M9502A-02

S E R V I C E N O T E

M9502A AXIe 2 slot Chassis

Chassis does not appear in the Agilent Connection Expert PXIO tree

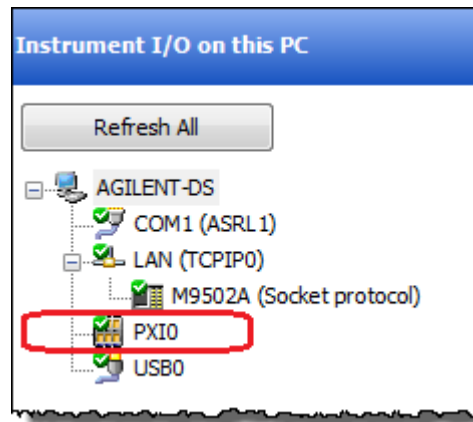
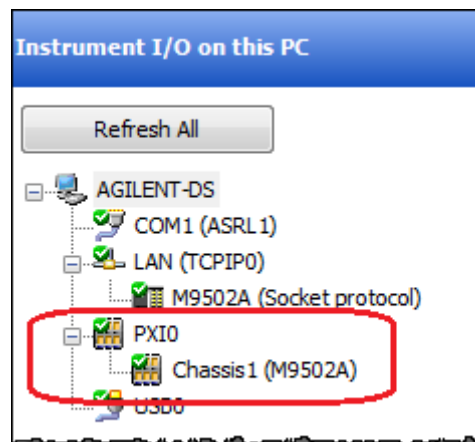
M9502A AXIe chassis that is connected through PCIe should automatically appear under PXIO tree in Agilent Connection Expert. It has been found that when using M9502A affected serial number, firmware, driver, and IOLS described above, the M9502A does not appear in the Agilent Connection Expert PXIO tree. See picture example below:

The chassis should automatically appear like this:

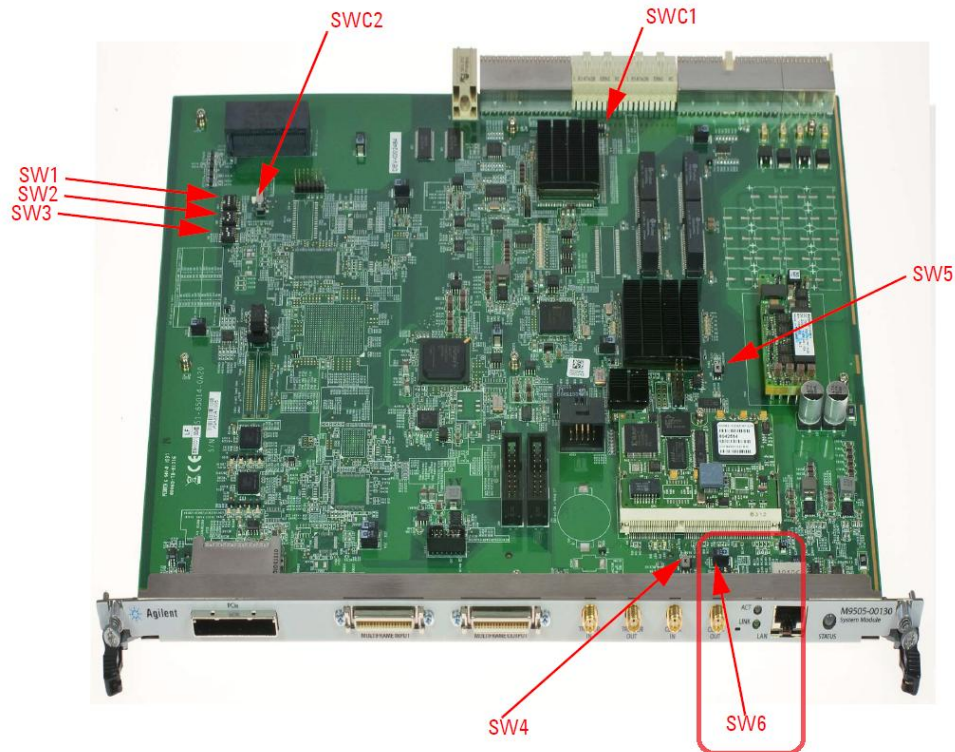
Reconfiguration of the chassis PCIe interface is needed to fix this issue. This can be accomplished by moving a particular DIP switch on the Embedded System Module (ESM), cycling power on the chassis, and then restoring the original DIP switch position. To reconfigure the chassis PCIe interface, perform the following steps:

1. Power off the M9502A chassis.
2. Remove the M9536A embedded controller from the chassis if you have an M9536A installed.
3. Remove the M9505-00130 or M9505-00230 ESM from the chassis.
4. Locate the DIP switch 6 (SW6) on the ESM as shown in the figure below.

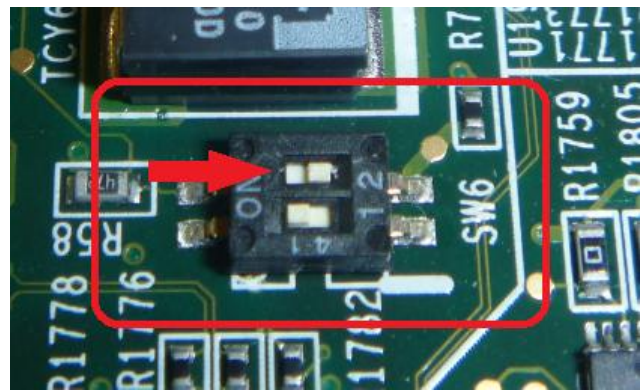
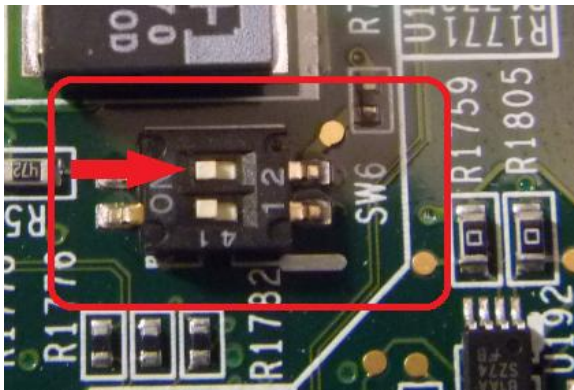
5. Locate the switch #2 of the DIP switch SW6 and change its position to the opposite position. If it is located on the left, switch it to the right. If it is located on the right, switch it to the left. See pictures example below:
